SN 34401A-13E

S E R V I C E N O T E

34401A 6 ½ Digit Digital Multimeter

**The Problem – Temperature drift out of accuracy specification on 3 Amp
DC/AC current range**

Layout diagram on the PC assembly

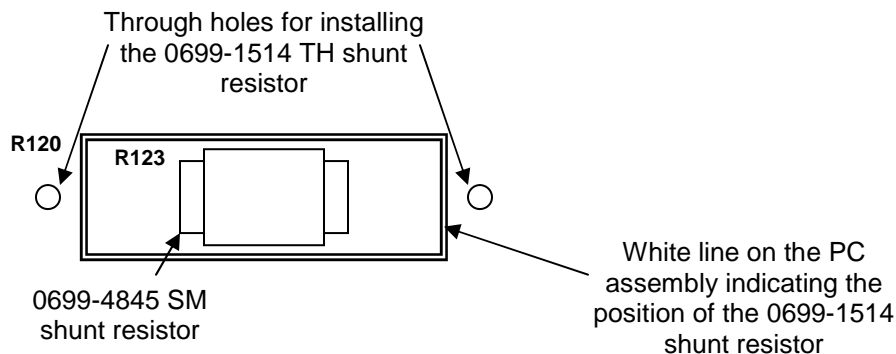
The 0699-4845 shunt resistors used on 34401A 3 Amp DC/AC current range may have a temperature coefficient which is higher than the required value. This will cause the voltage drop across the shunt resistor to drift out of specifications while measuring continuous current levels above 2 Amp (for example, >30 sec at 3 Amp). However, this measurement drift does not affect current measurements using the 10 mAmp, 100 mAmp, or 1 Amp current measurement ranges, nor will it affect 3 Amp DC/AC range measurements if they are not made continuously for >30 seconds.

The 0699-4845 shunt resistor should be removed and replaced by the through-hole shunt resistor 0699-1514. The following figure indicates the relative positions of the 0699-4845 shunt resistor and 0699-1514 shunt resistor. The 0699-4845 is an SMT component and should only be removed by a technician skilled in the repair of surface mounted components. Damage to the PC assembly can occur unless the proper tools are used to remove the shunt resistor. The PC assembly has undergone special washing to achieve High-SIR. Proper handling and reworking technique should be practice avoid contaminating the PC assembly which, could lead to performance related problems. The unit must be calibrated after replacing the 0699-4845 shunt resistor.

1. Output 2.8A DC from the calibrator and measure this current with the 34401A. The measured value should meet or exceed the 2.800000 +/- 0.004 A one year accuracy specification. If it fails, skip the following test steps and do the repair.
2. Be sure that the test current is continuously connected the 34401A during this entire procedure in order to see any drift due to heating the internal 0.1 ohm current measurement shunt resistor.
3. Repeat this measurement again after one minute and verify that the result meets the accuracy specification.
4. If the 34401A fails this test, replace the surface mount R123 current shunt resistor using the following repair procedure
